Modification Bulletin

Model: NAD 30S/30/40 LCT (RT36)			te: 30-Aug-0	0	No.: MA683001		
Modified Article: Side Plate				Prepared by: E. Fukuyama			
From: Technical Services Dept., GTS Division							
Reason for	eason for Parts catalog correction		hange	☐ To n	neet standards		
Modification: ☐ To facilitate assembly ☐ T		☐ To improve reliability		()		
	☐ Part standardization	Other

Modified Article: Hinge Bracket

Modified Article: F	rame – Large Capacity Tray	Prepared by: Y.Urushihara			
From: 1st Tech. Support Sec. Service Support Dept.					
Reason for	☐ Parts catalog correction	☐ Vendor change		☐ To meet standards	
Modification:	☐ To facilitate assembly	☐ To improve reliability		()	
	☐ Part standardization	Other

3.PAPER TRAY (A683)

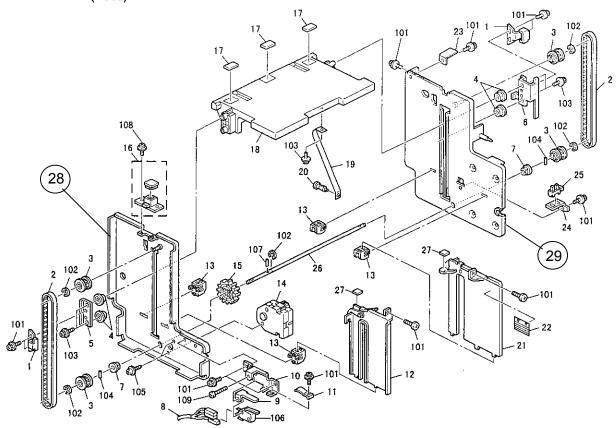
The following have been registered as service parts.

New part number	Description	Q'ty	Int	Page	Index
A6832550	Side Plate : Front	0-1	-	7	28
A6832560	Side Plate : Rear	0-1	-	7	29
